DATE: 2023-05-24

MODEL: SR3 XXR/SR10

PEDAL POSITION SENSOR WATER INGRESS

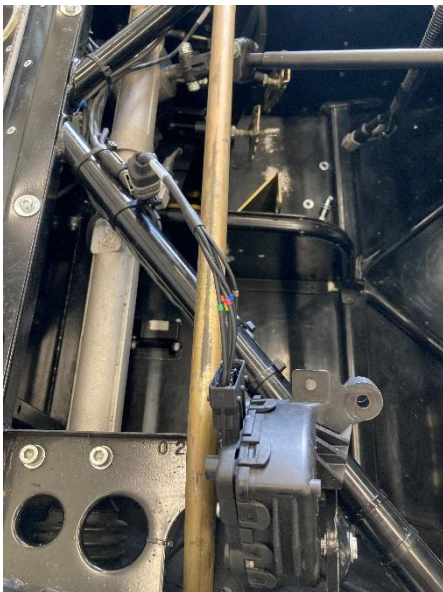
In extreme wet conditions water ingress has been found into the Pedal Position Sensor (ET0072). This can cause electrical issues. To prevent this issue customers are advised to apply the following reliability modification:

1. Remove the PPS from the car.
2. Place the PPS on bench or lock in vice to have good access to the wiring coming out of the sensor.
3. Carefully remove all silicone and trim the excessive heat shrink sticking out of the sensor.

4. To confirm the sensor is fully functional and no connections have been disturbed plug the unit back into the car and check functionality using LifeMon or dashboard.

5. Re-pot the sensor using silicone or alternative potting compound, be sure to cover entire space around the wiring.
6. Let it dry in stable position before re-installing to the car.
